City of Hastings

Planning Commission Memorandum

To: Planning Commission Members
From: Justin Fortney, Associate Planner
Date: November 26, 2012
Item: Site Plan Review – Las Margaritas expansion #2012-45 –2100 Vermillion Street.

ADDITION FOR: LAS MARGARITAS RESTAURANT

② SITE PLAN
1/4" = 20'-0"

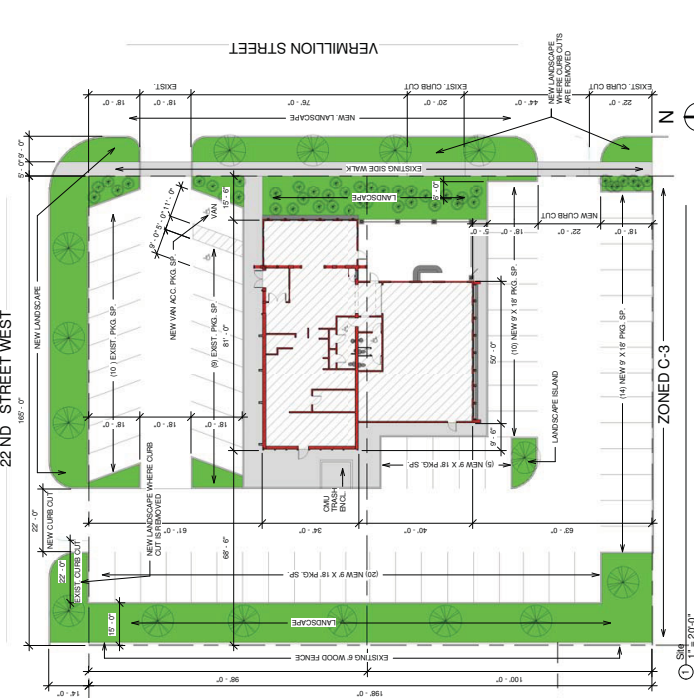
There are currently three driveways into Highway 61. The applicants propose to close one of them. The Minnesota Department of Transportation is requiring them to close a second driveway near 22nd Street West. They are appealing this decision. The applicants are asking that the city consider approving their original plan and alternate "A" incase their appeal is denied.

The proposed parking plans meet the City parking standards. However, if MnDot denies their appeal and alternate "A" is required, they will be short two parking spaces. Staff believes this is reasonable because it is an impact to an existing parking lot and is part of a site redevelopment.

- 6) Site access per option "A" if MnDot access closure of north drive is not rescinded.
- 7) The property owners must enter an agreement with the City signifying their responsibility for all dormant utility services.
